East Devon Local Plan, 2020-2040 (Lympstone)

Comments from the Lympstone Flood Resilience Group

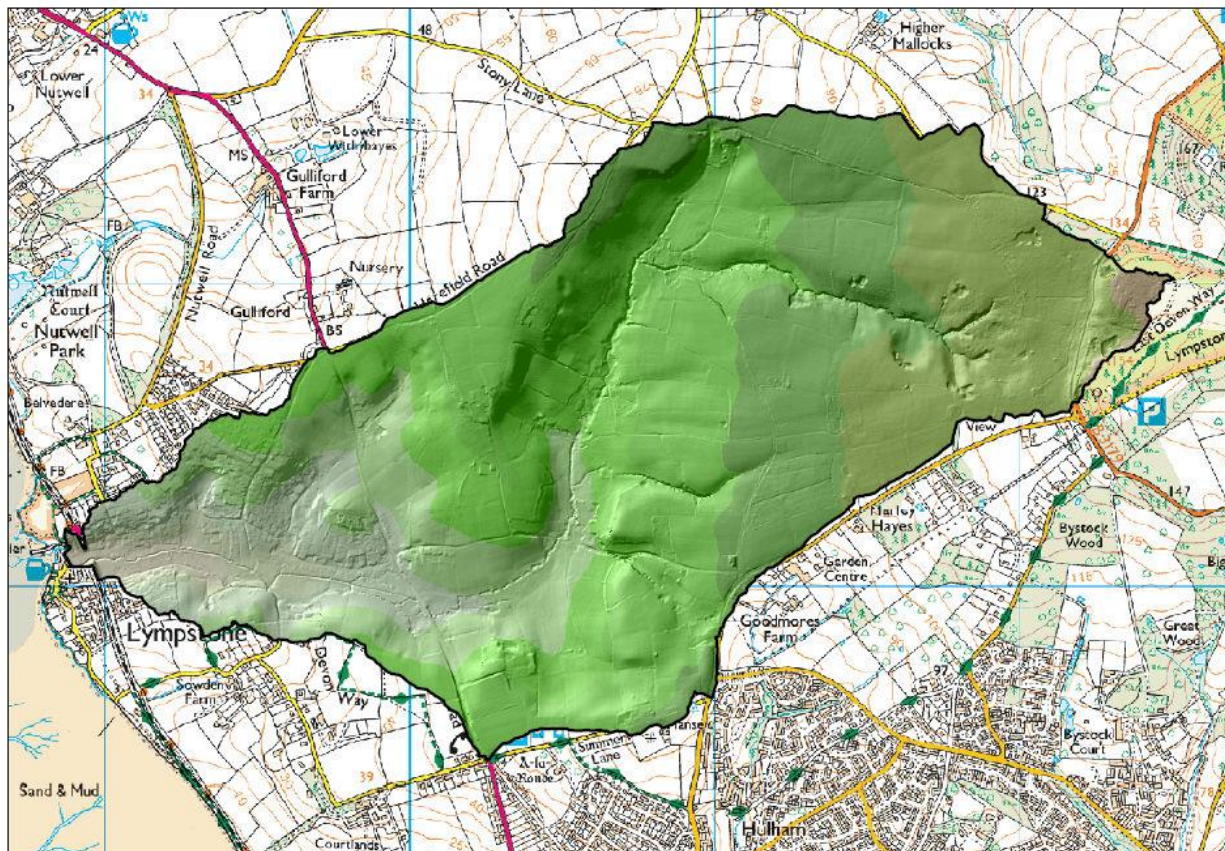
The Wotton Brook Catchment is the most critical concern regarding new developments, and our principle is that with appropriate SUDS attention, any new developments should improve on the pressure that the catchment places on Lympstone Village and its flooding potential.The catchment, shown in the LIDAR diagram below, is a rapid response catchment as defined by Devon County Council and The Environment Agency and as such has been extensively modelled and studied with the objective of reducing the 'flashy' runoff which currently occurs, and which in turn can flood the village.

There is a very real possibility of increasing the flood risk to the village without very careful analysis. We understand that a Strategic Flood Risk Assessment has been commissioned by the District Council. We have requested that Lymstone Flood Resilience Group, a working group of Lymstone Parish Council be consulted in the preparation of this assessment.

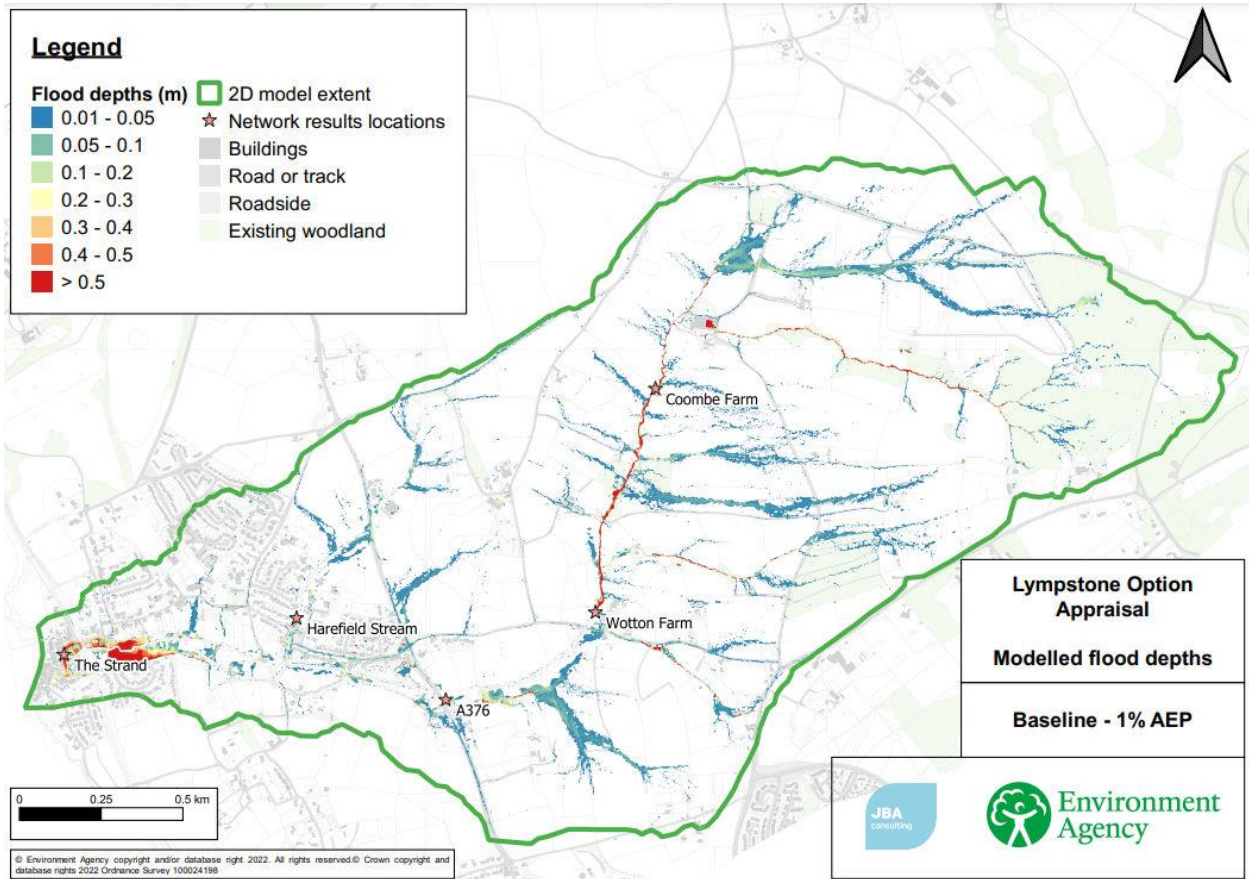
LP Lymp 09 and LP Lymp 10a are a major concern. An example of the runoff from these locations is shown below, and it can be seen that drainage from the north side of Hulham Road has great sensitivity. The blue lines indicate current surface runoff as modelled, and as previously mentioned various NFM Measures to reduce the runoff are being explored with landowners and are under consideration under DRIP. Retention or attenuation in this area would be critical to ensure that the targets set for the NFM improvements to this area are matched or bettered. We are concerned that this area is potentially very unsuitable for development for these reasons.
